Proposed Space Alteration for the:
Sara & Sam Schoffer H.R.C.
Stockton University
101 Vera King Farris Drive, Galloway Twp., NJ
SHEET TITLE: **LIGHTING**

ADDENDUM #1
11/13/2018

ADDENDUM 1 11/13 /2018

POWER LAYOUT
SCALE: NOT TO SCALE

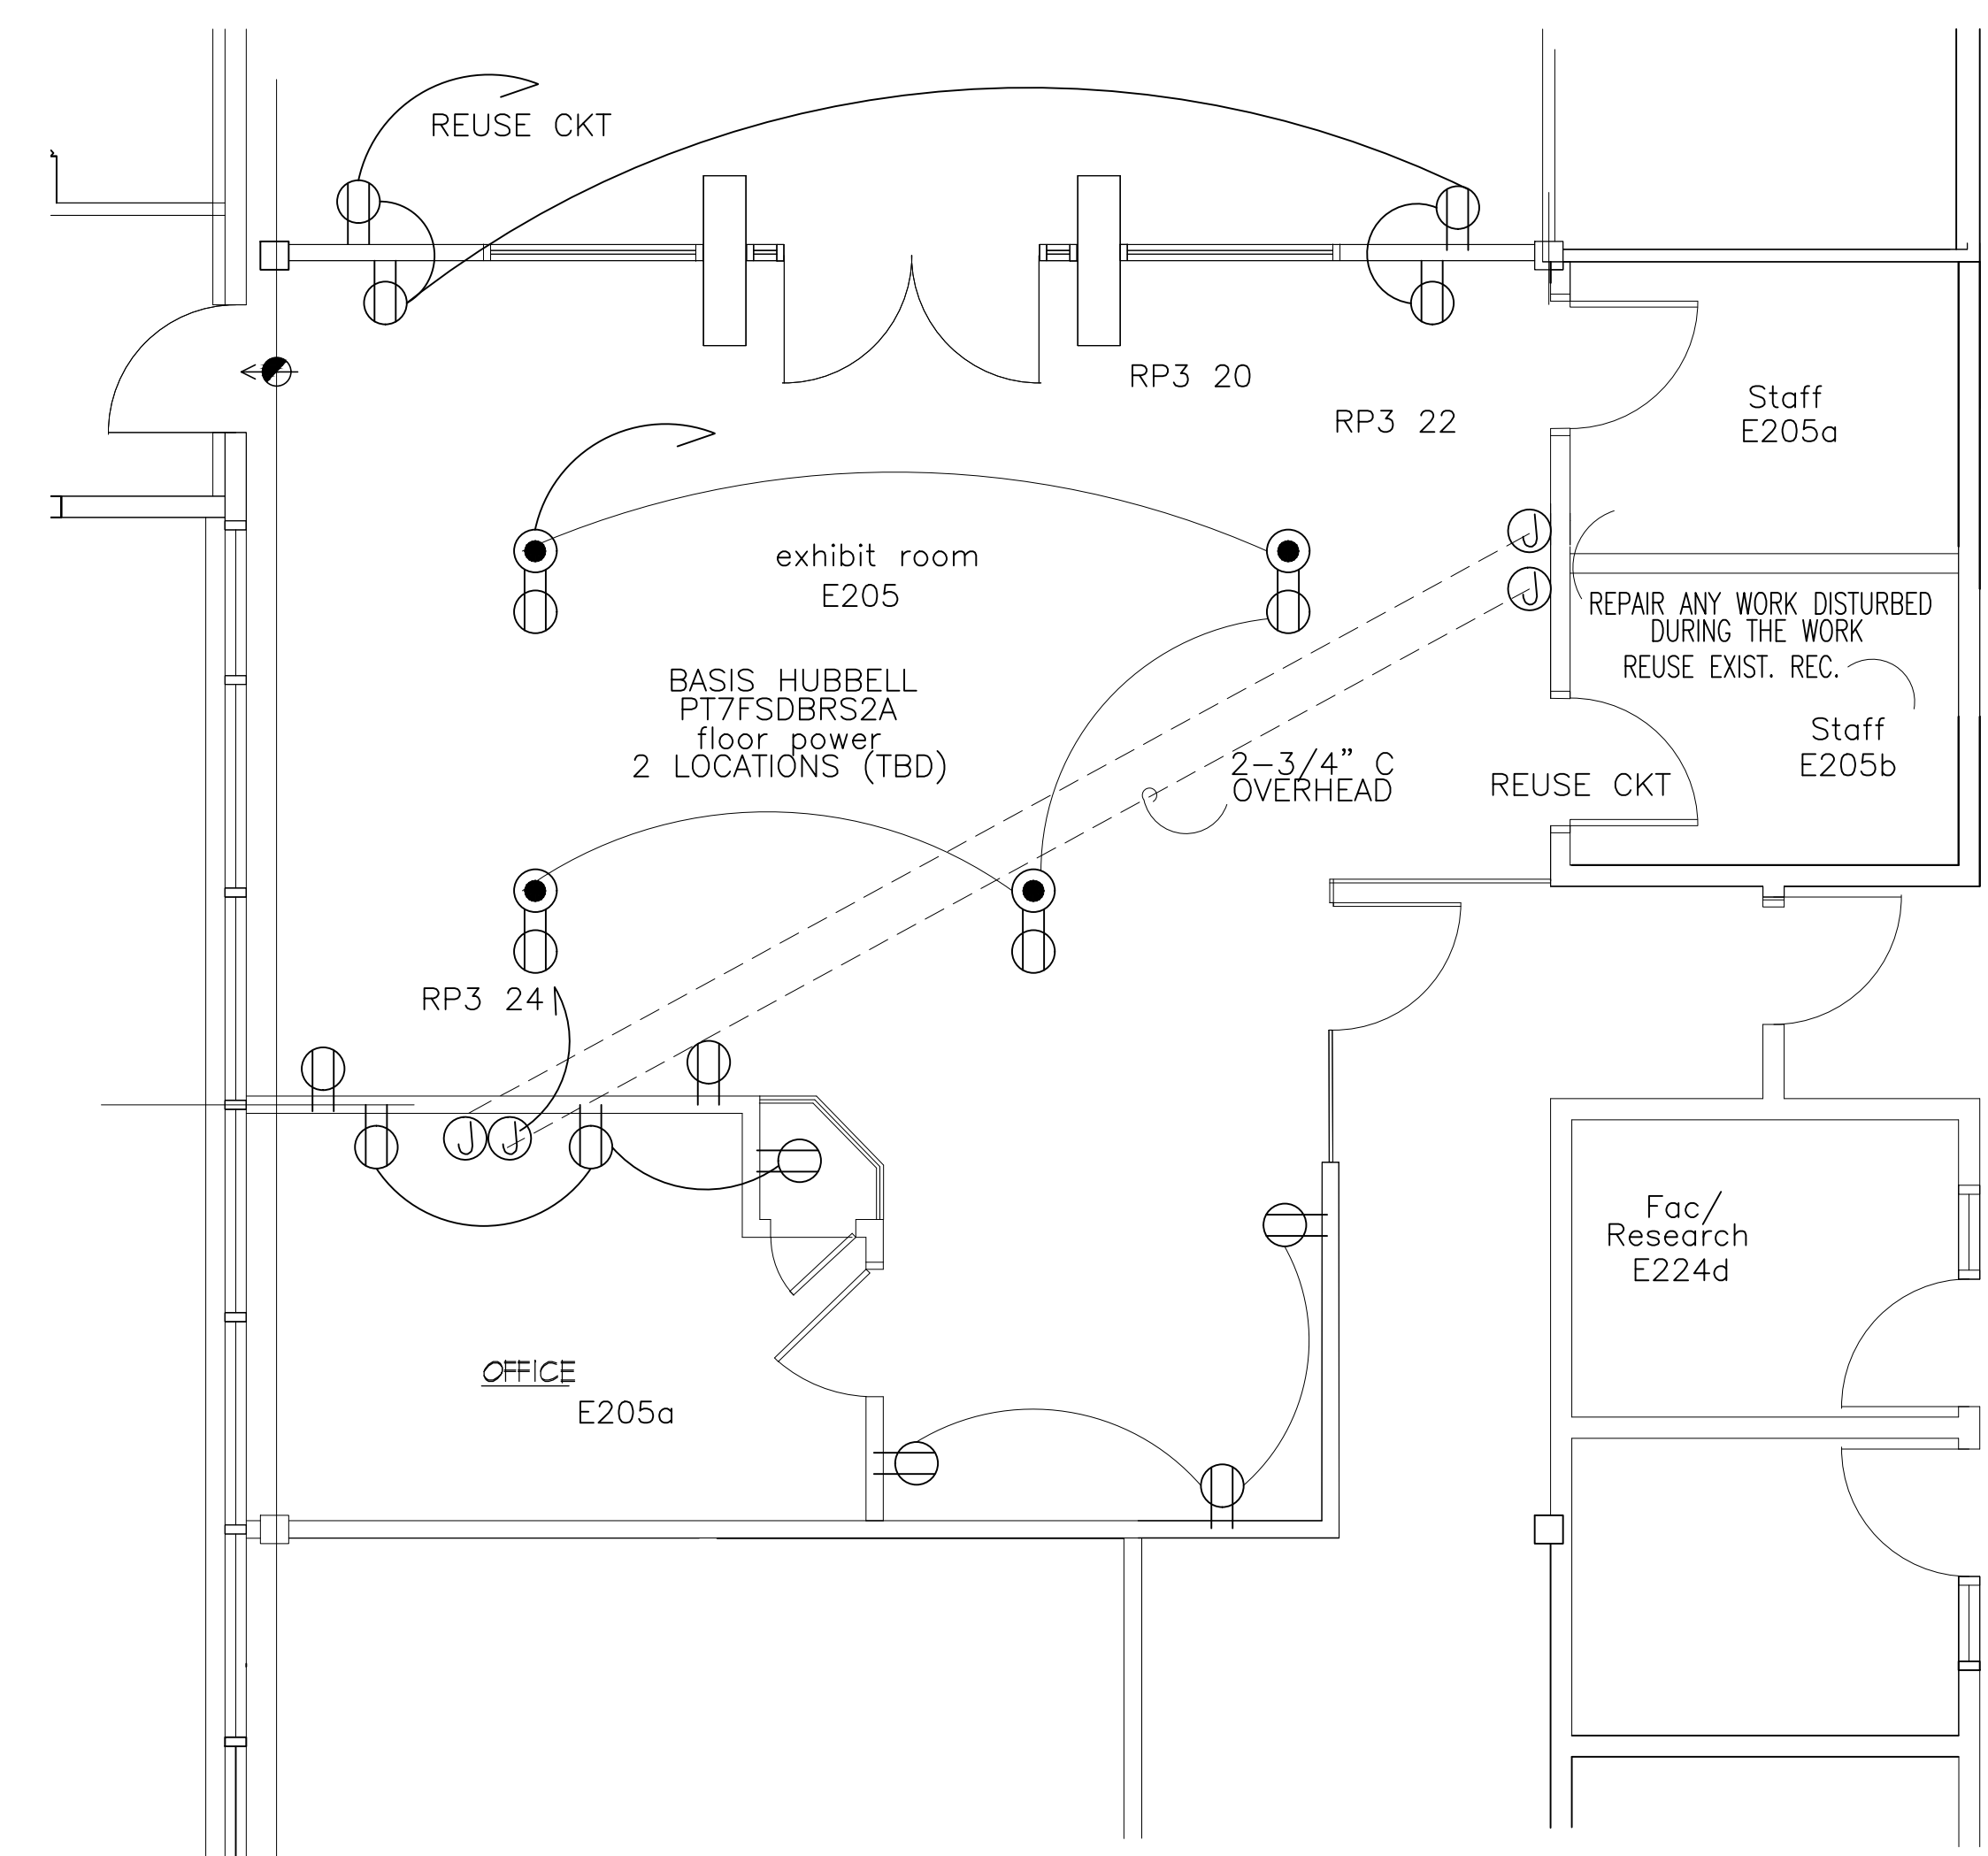
- FURNISH EMERGENCY LIGHTING IN ACCORDANCE WITH 2015 INTERNATIONAL BUILDING CODE - NEW JERSEY EDITION.
- ~~BATTERY POWERED UNITS SHALL BE RATED FOR CONNECTED LOAD FOR 1.5 HOURS WITHOUT FALLING BELOW 87.5% OF APPLIED VOLTAGE.~~

EXISTING PANEL RP3-2 - LOAD CENTER TYPE						
KVA	CIRCUIT	NO.	BREAKER	NO.	CIRCUIT	KVA
0.4	REC. TV MONITOR ROTUNDA	1	20/1	20/1	2 REC. LECTERN, PROJ, SCREEN, STOR.	0.7

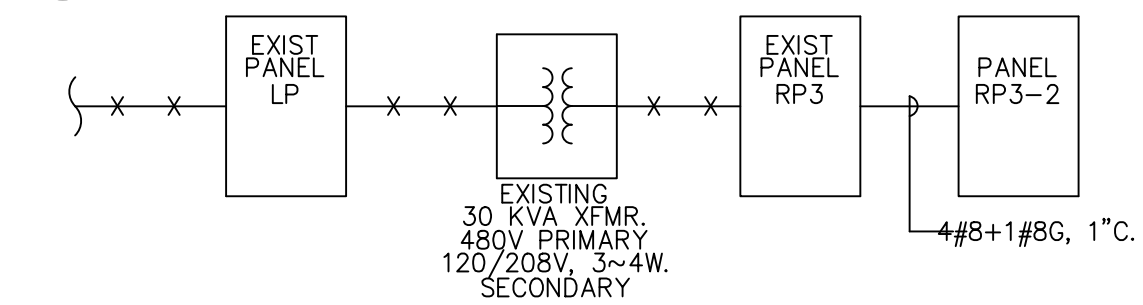
use this panel for new circuits
